Agenda
Village of Arlington Heights
Design Commission
Community Room, 3rd floor

Arlington Heights Village Hall
33 S. Arlington Heights Road
Arlington Heights, IL 60005
July 9, 2019
6:30 PM

STAFF DESIGN COMMISSION REPORT

Project Name: 836 N. Dunton Ave.
Project Address: 836 N. Dunton Ave.
Prepared By: Steve Hautzinger

Proposed Exterior Elevations

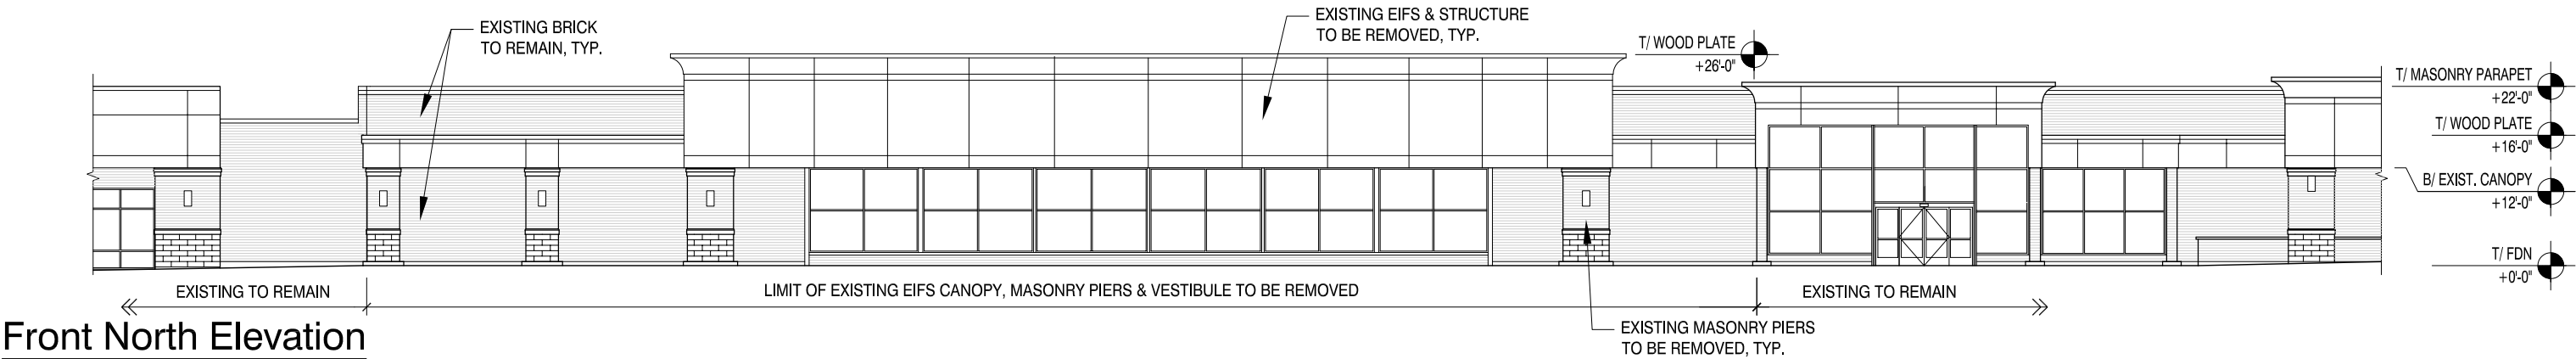
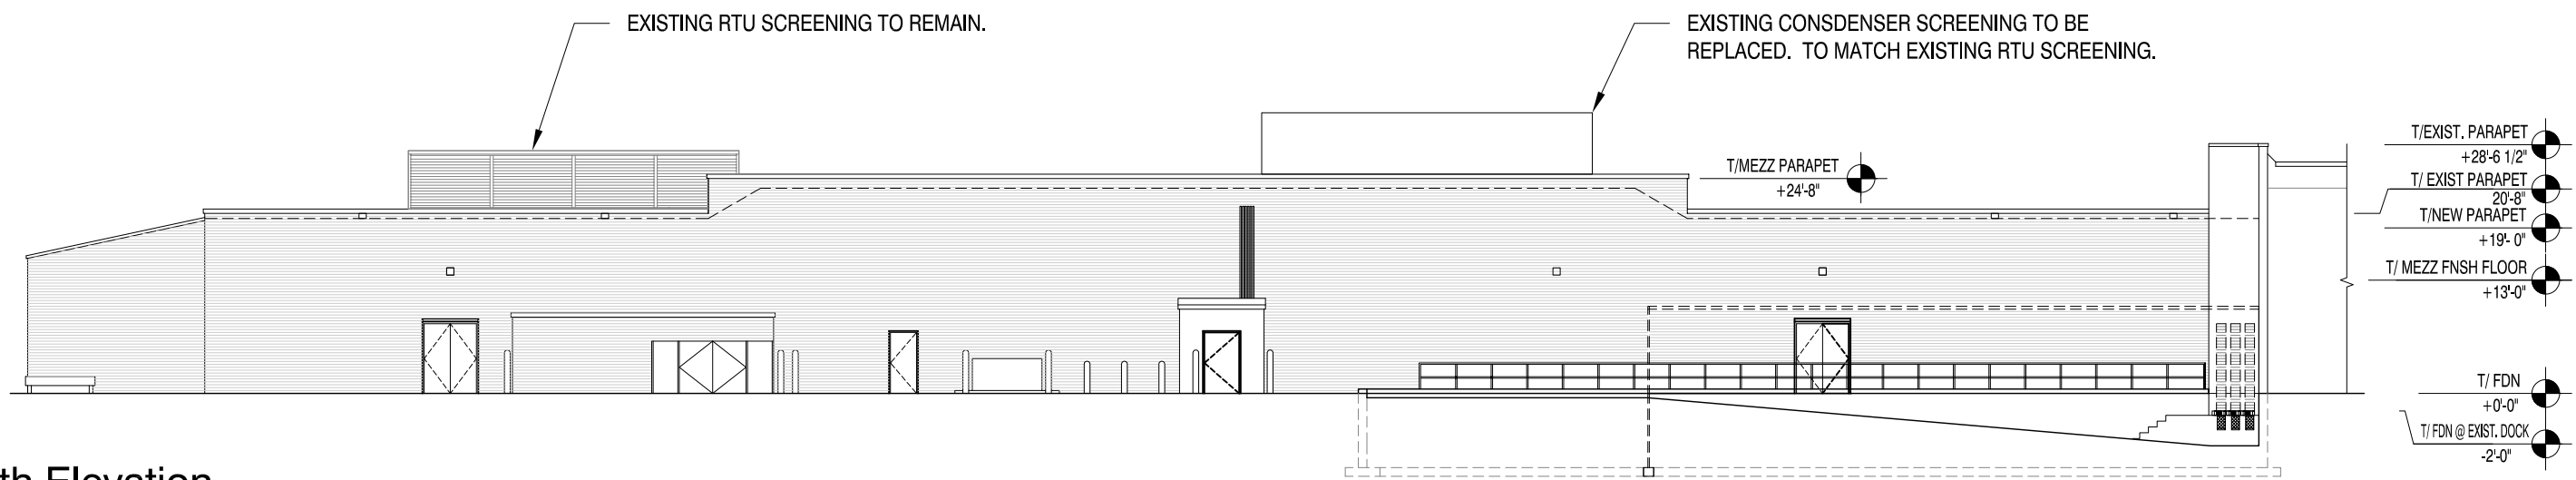
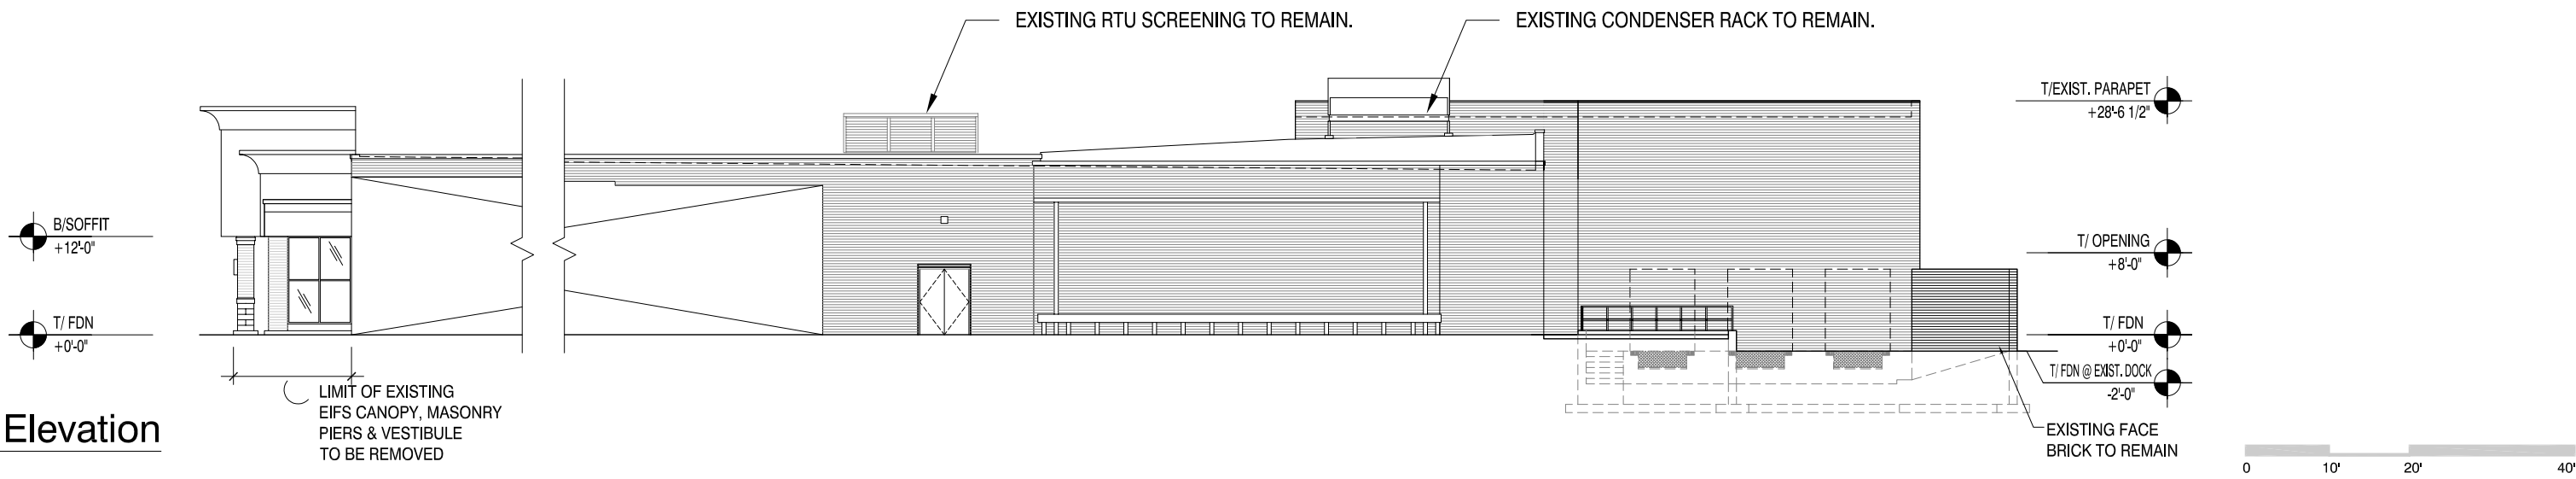
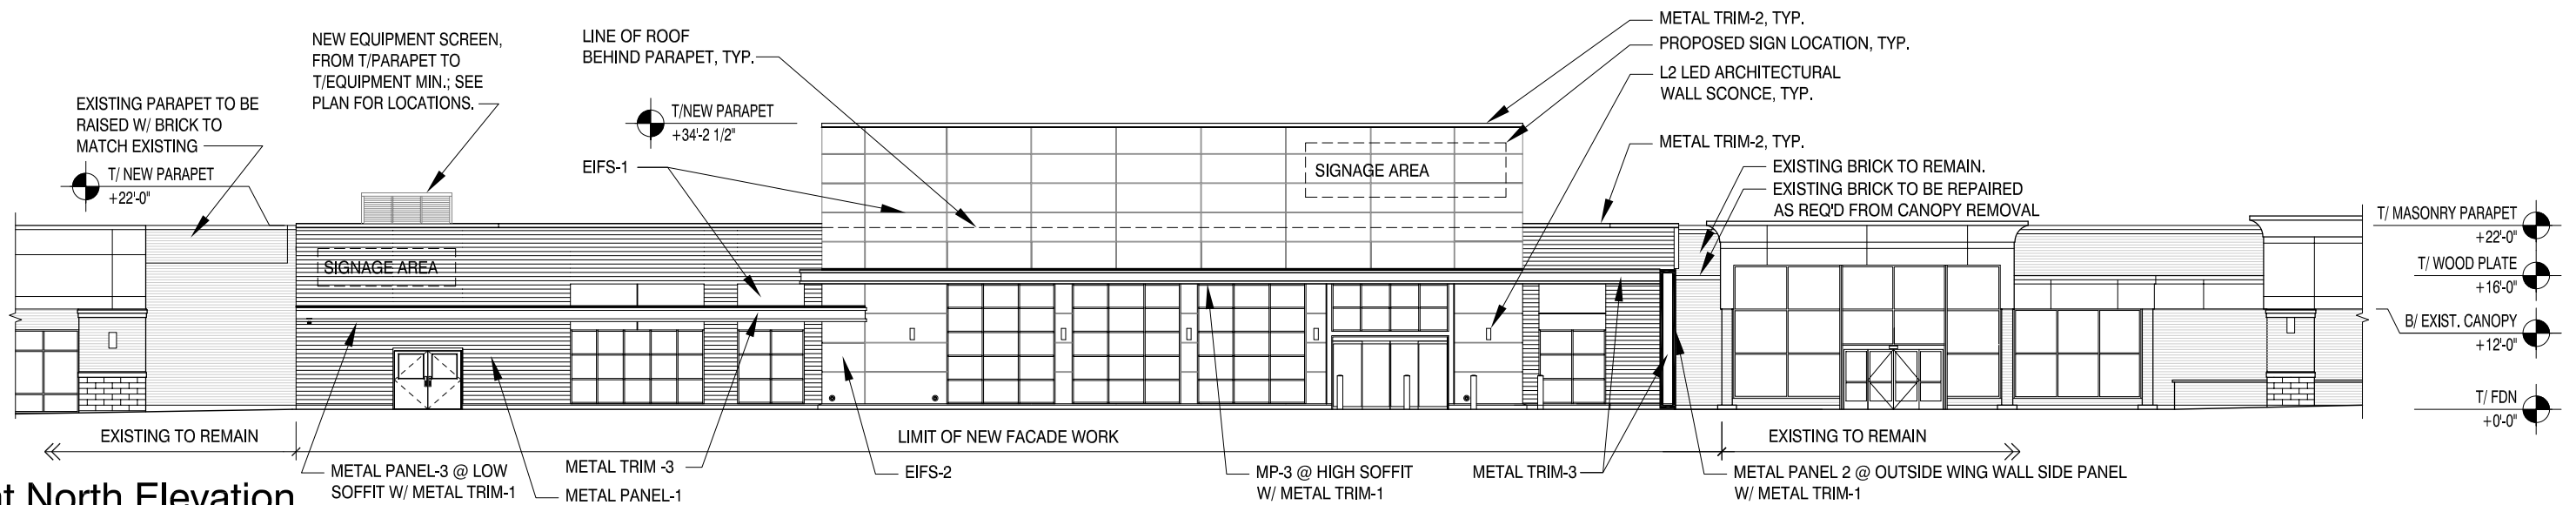
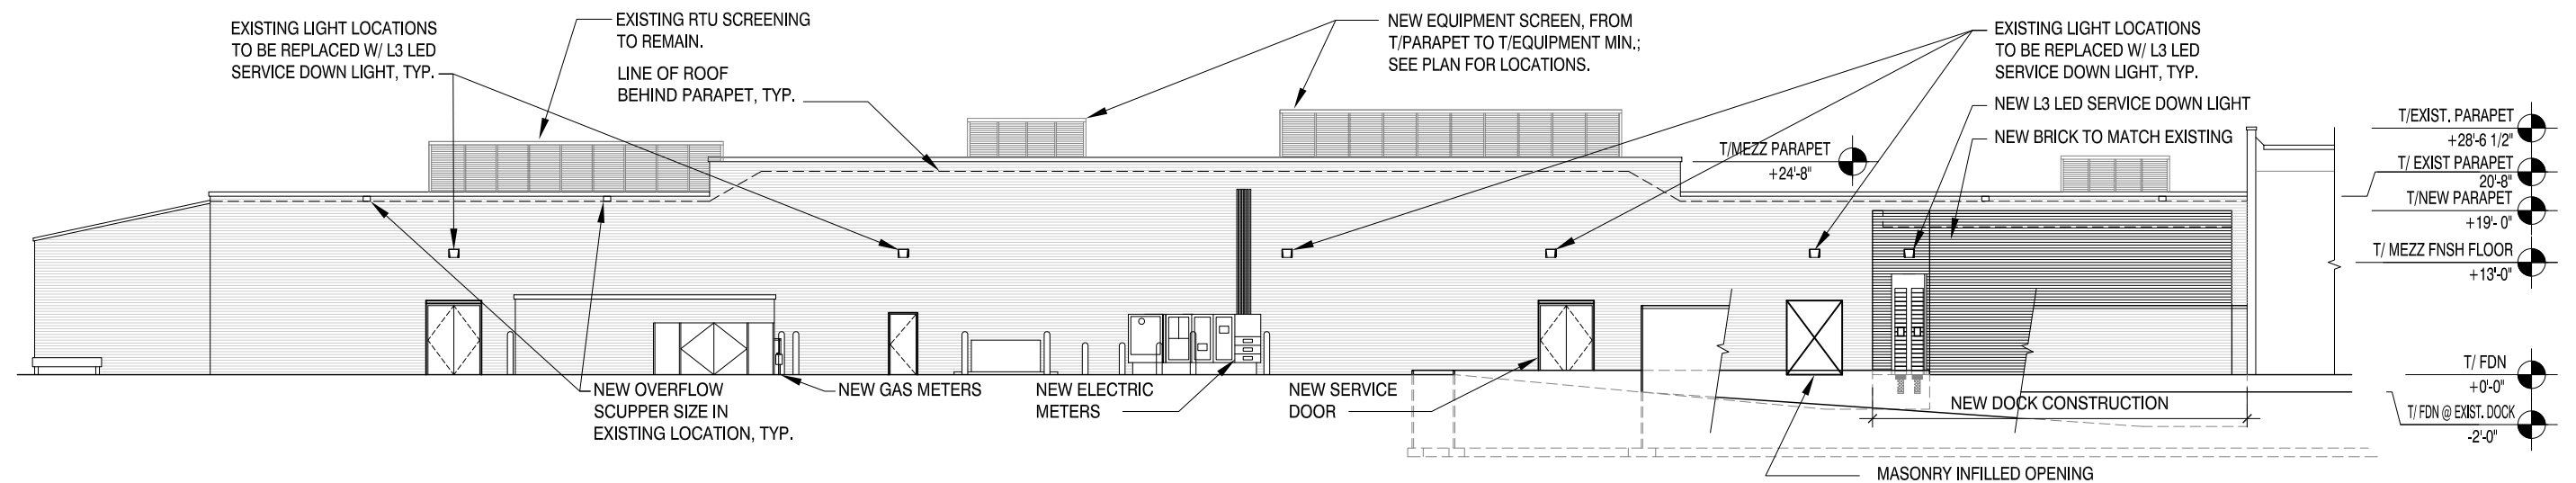
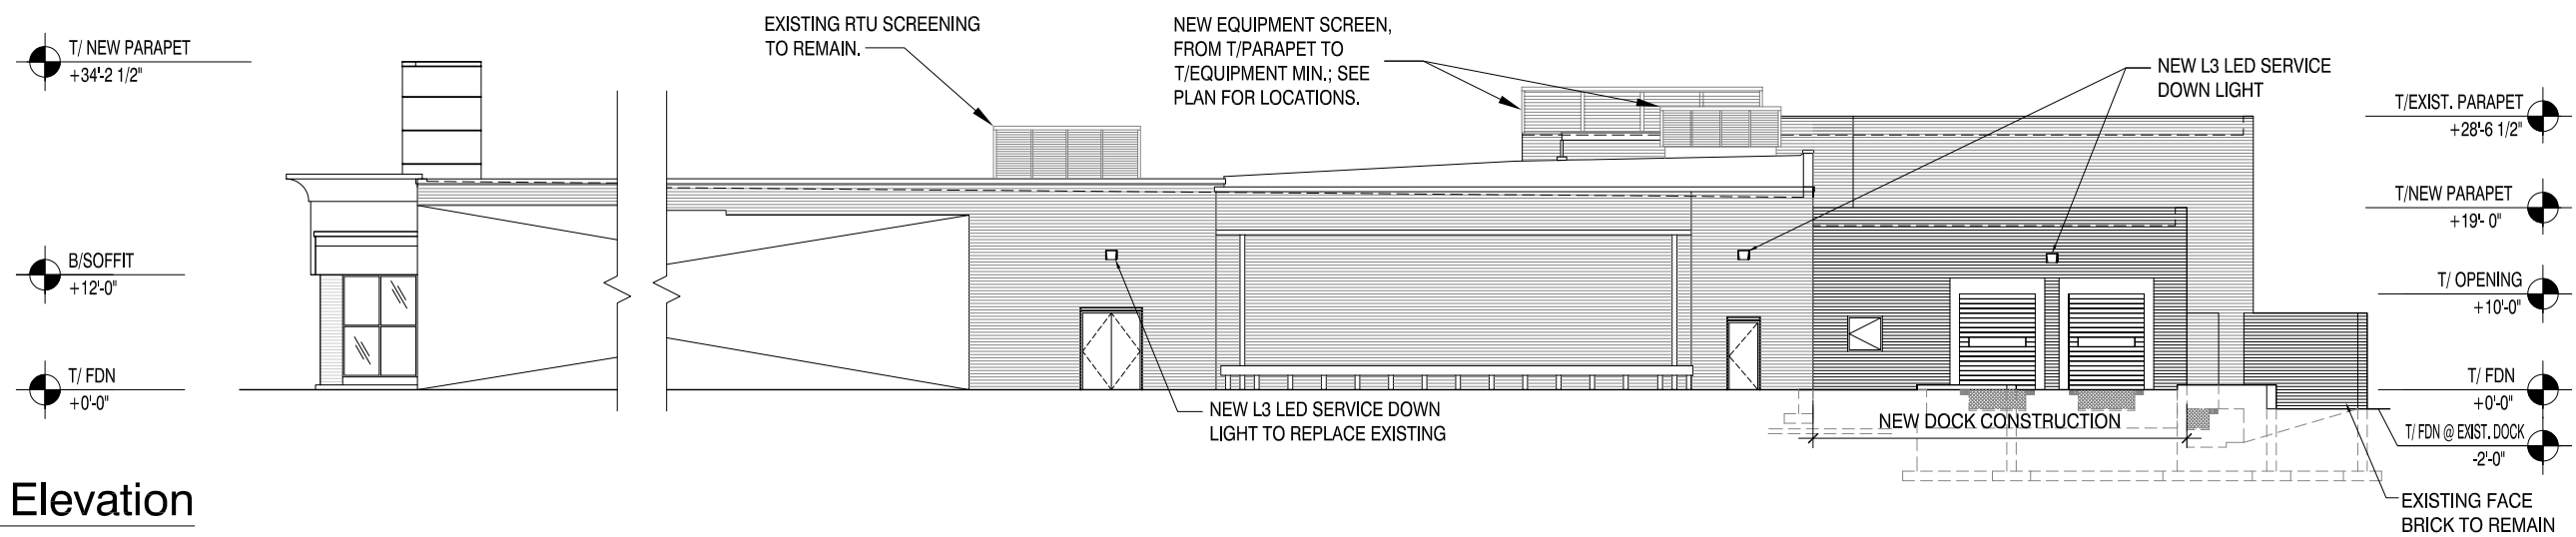
1. Evaluate the proposed design for cohesiveness with the context of the existing retail center.
2. Explore options to help tie the proposed design in with the existing retail center, such as enhancing the cornice detail at the top of the walls to complement the adjacent stores.

3. Evaluate the use of EIFS down low on the façade and in contact with the concrete walkway due to concerns of durability and possible damage.
4. This review deals with architectural design only and should not be construed to be an approval of, or to have any other impact on nor represent any tacit approval or support for the proposed land use or any other zoning and/or land use issues or decisions that stem from zoning, building, signage or any other reviews. In addition to the normal technical review, permit drawings will be reviewed for consistency with the Design Commission and any other Commission or Board approval conditions. It is the architect/homeowner/builder's responsibility to comply with the Design Commission approval and ensure that building permit plans comply with all zoning code, building permit and signage requirements.
